ADDRESS: 1819 LEVERETTE

APPLICATION NO: HDC2024-00560

HISTORIC DISTRICT: CORKTOWN

SCOPE: ERECT A REAR ADDITION

Rear porch (left) and window (right) proposed for removal. Photos provided by applicant

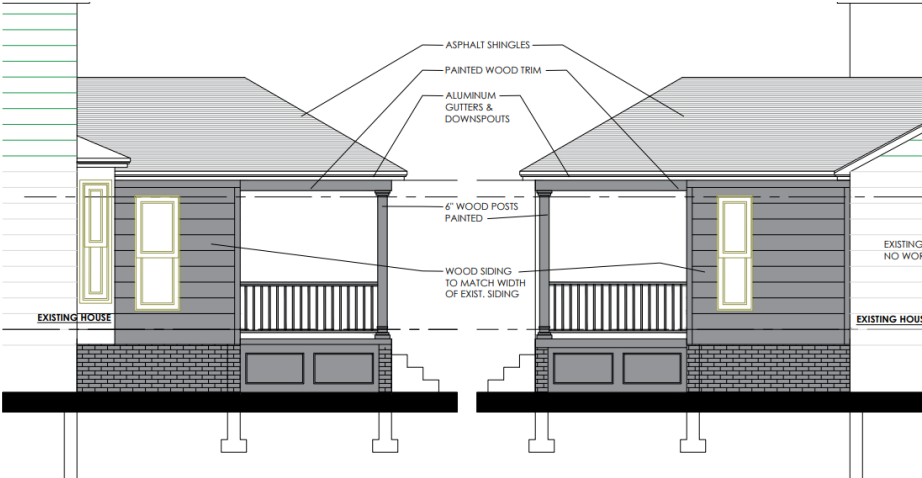
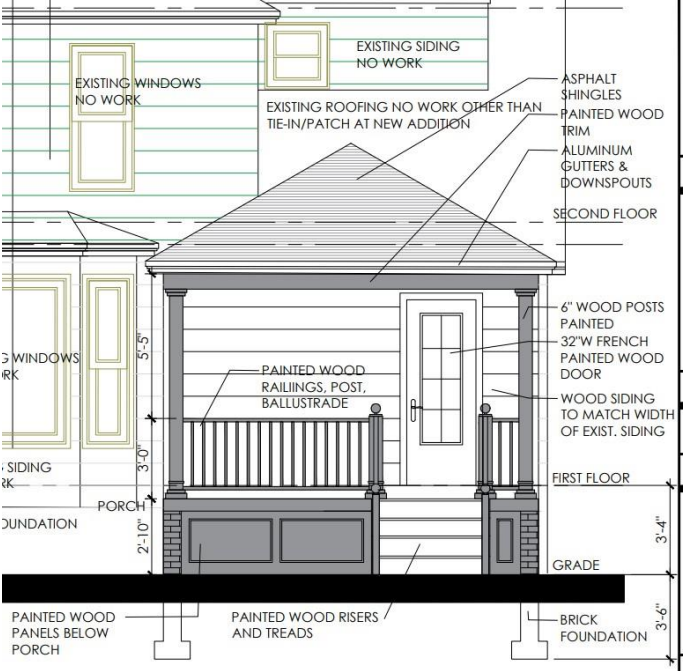
- The existing rear porch is utilitarian in nature and includes wood steps (wood risers, treads, and stringer), wood decking, plywood skirting, and an open wood handrail. The porch appears to have been haphazardly constructed, is in poor condition, and likely does not date from the building's original construction. It is staff's opinion that the porch proposed for removal is not a distinctive character-defining feature which merits retention.

- The vinyl window which is proposed for removal is not historic age and detracts from the building's historic character
 - While the door is of historic age, it is utilitarian in nature and does not display detailing which meaningfully contributes to the building's historic character

As stated previously, the house has always had a rear porch and the new addition will include a porch space, thus ensuring that this historic condition will be maintained. It is therefore staff's opinion that the proposed work will not result in the removal of distinctive character defining historic materials, spaces or features that characterize the property
